Rocky Hill Senior/Community Center Addendum #3 04.14.2020

- REVISED** Sheet C.401 Grading Plan
REVISED Sheet C.402 Grading Plan
REVISED Sheet A2.1b Reflected Ceiling Plan
ADD Sheet A5.11 Wall Section

RFI Clarifications Front End and Bid Documents

RFI Clarifications Drawings and Specifications

**REFLECTED CEILING PLAN-
 PART B**

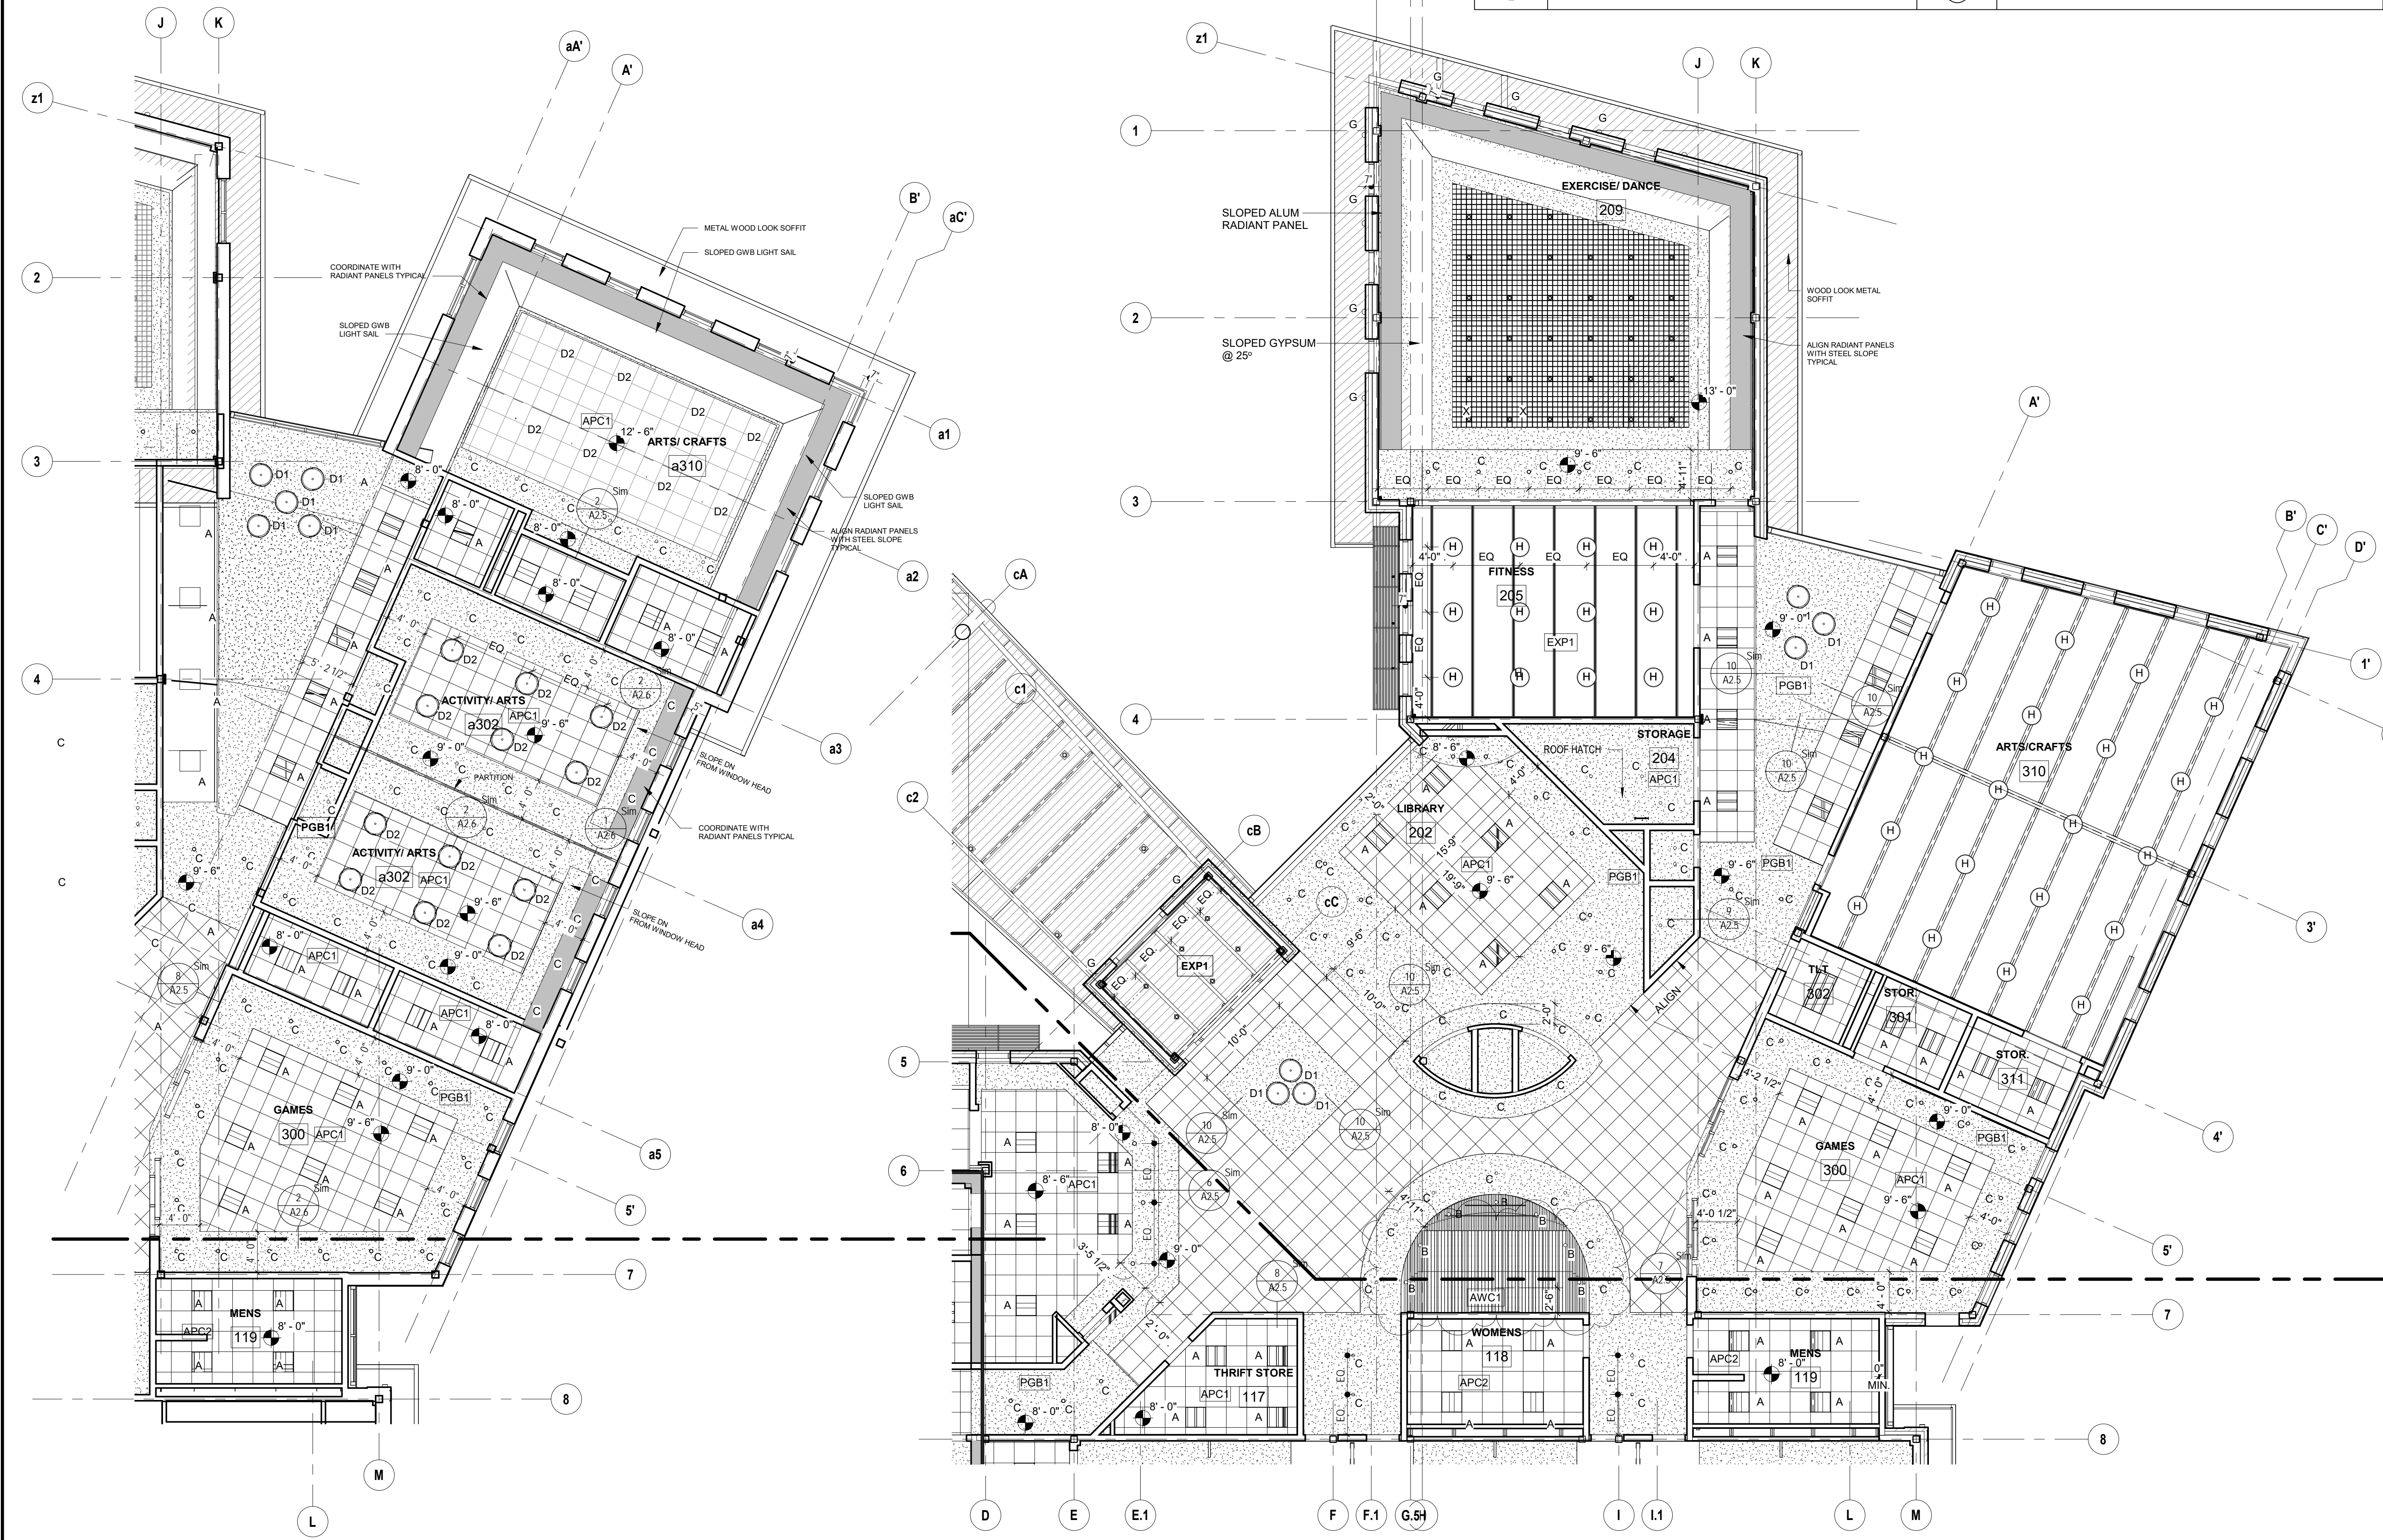
5. Please provide the ceiling types in the following rooms: Corridor 101, Corridor 102, Storage 301, TLT 302, Storage 311.

Corridor 101- APC1 acoustic tiles where 2x2s are shown and then PGB1 at gyp. conditions

Corridor 102- APC1 acoustic tile

Storage 301 (Games Storage)- APC1 acoustic tile

Toilet 302- APC2 (Ultima Health) acoustic tile

Storage 311 (Arts & Crafts Storage)- APC1 acoustic tile

1 WALL SECTION @ MULTI-PURPOSE ROOM
 A5.11 3/4" = 1'-0"

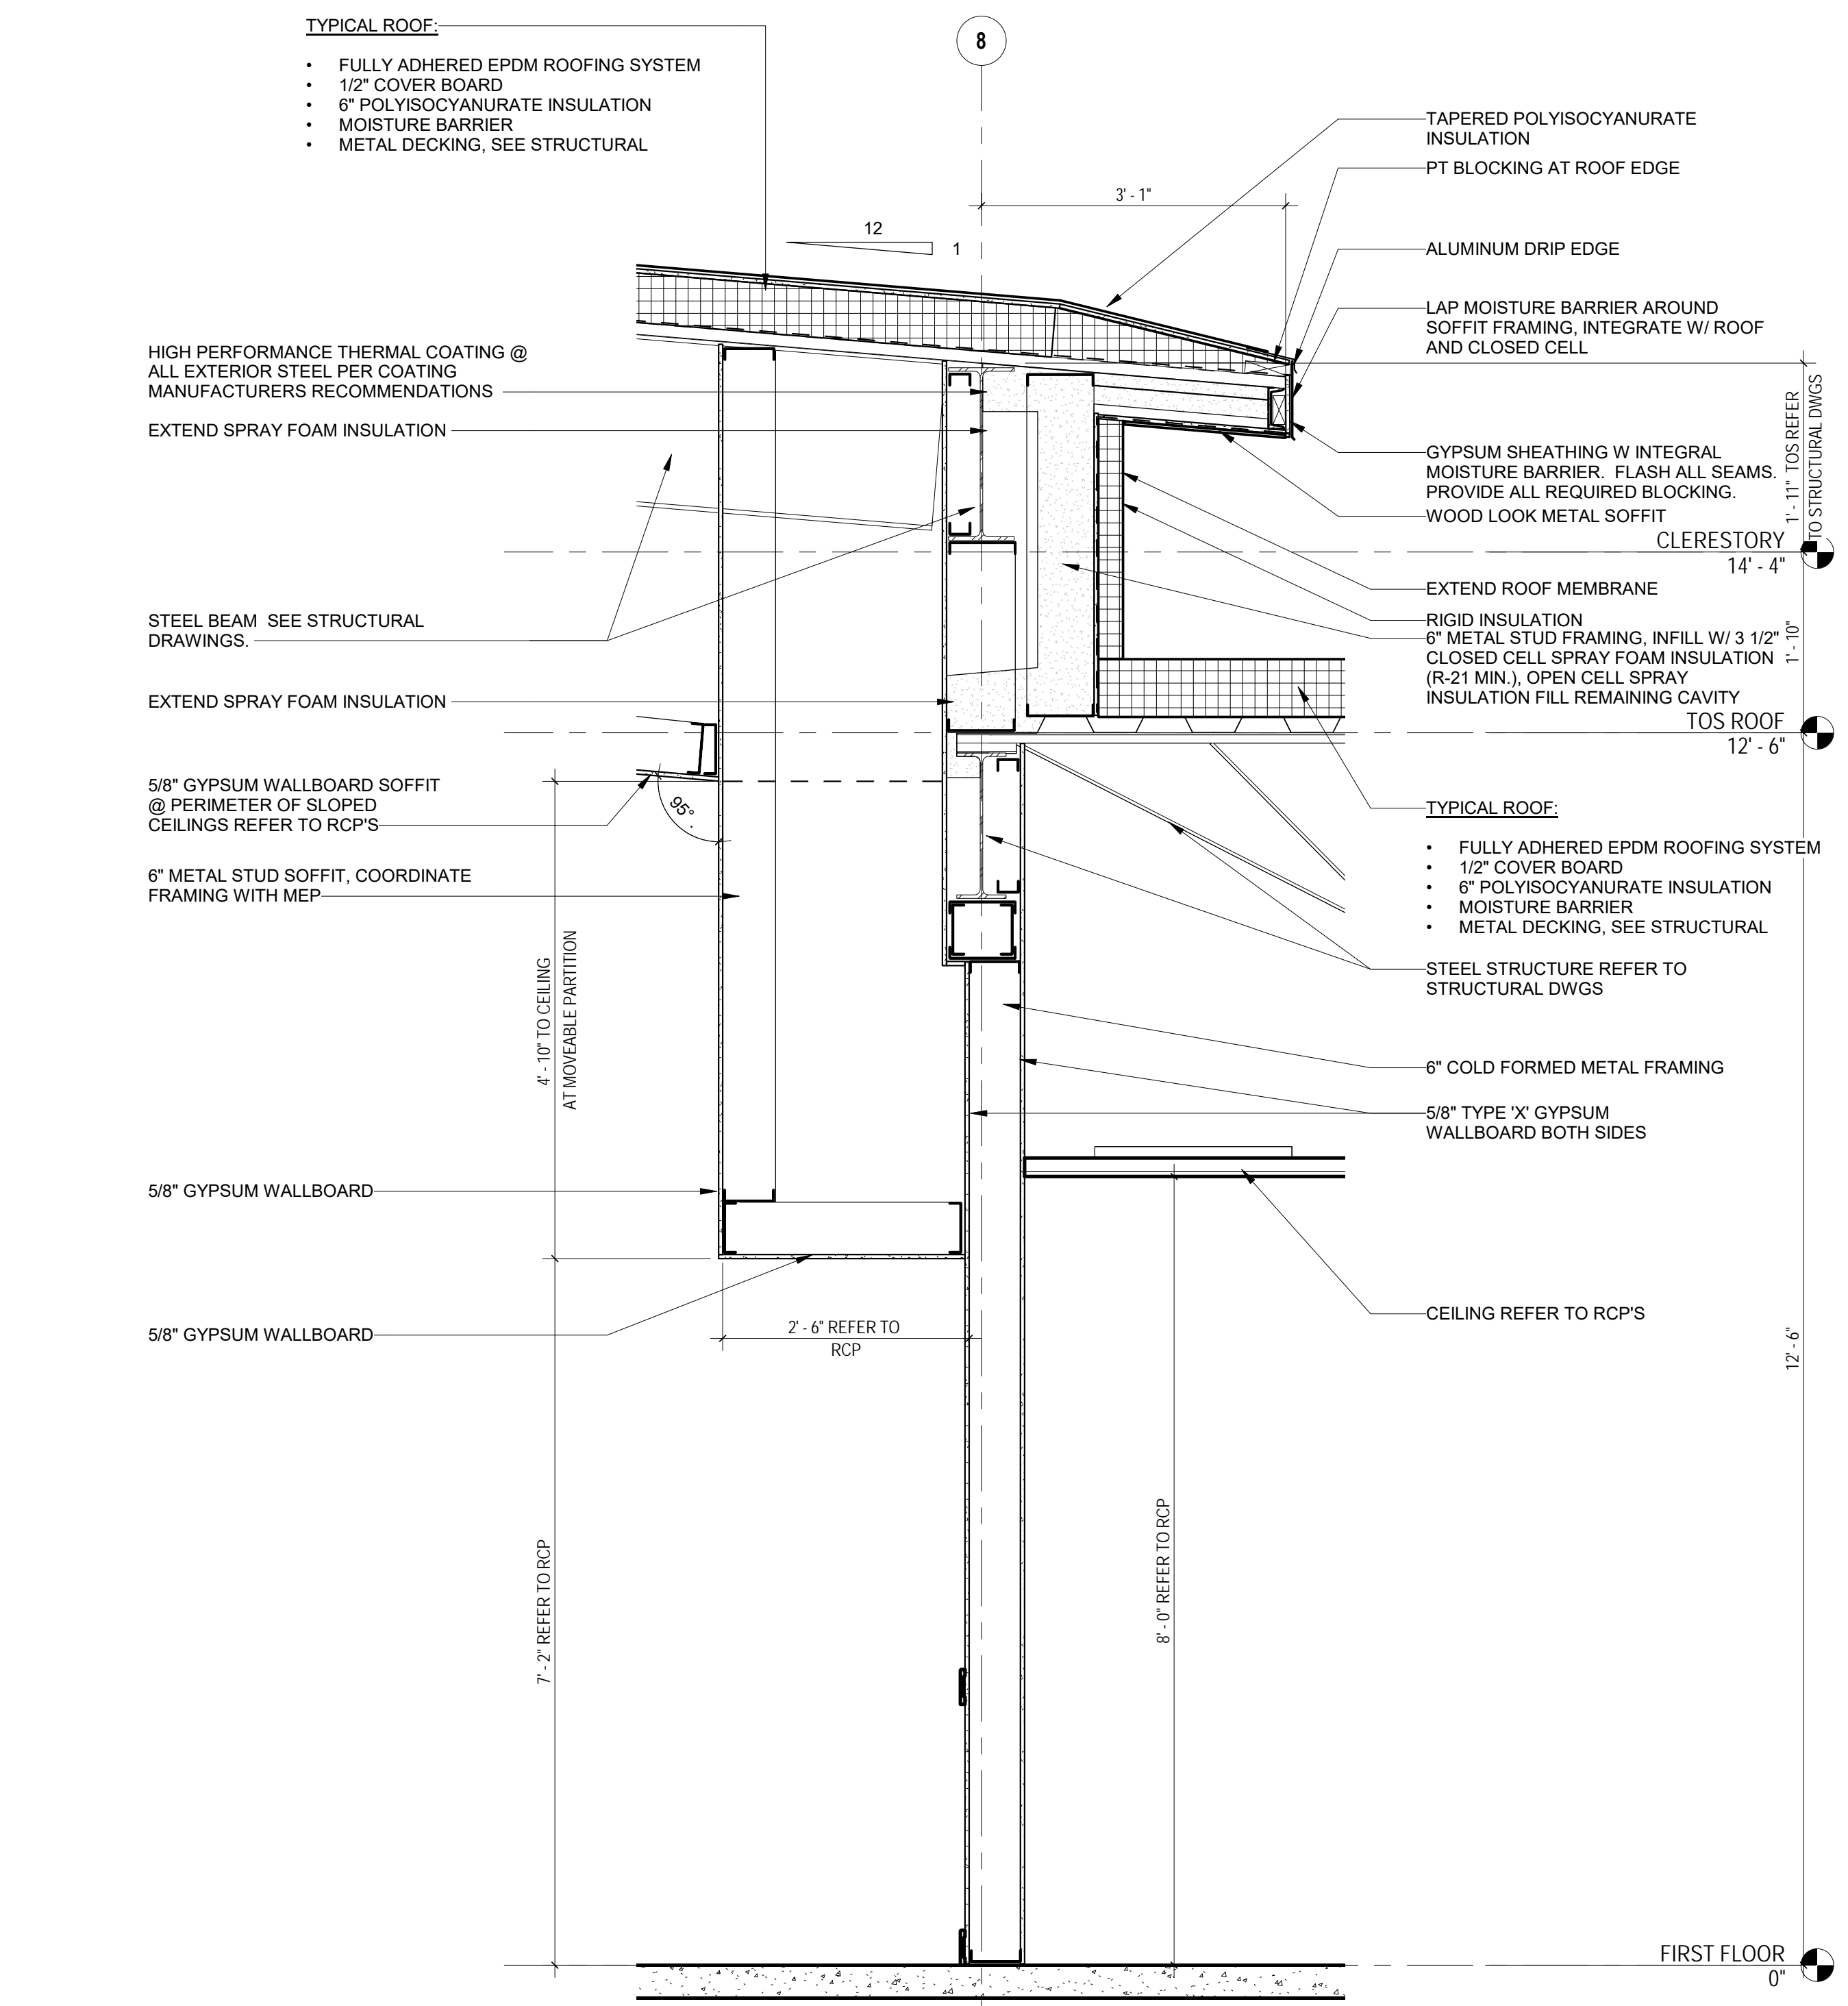
3. Please provide a section detail between the upper roof of the Multipurpose rooms & lower roof

See Attached.
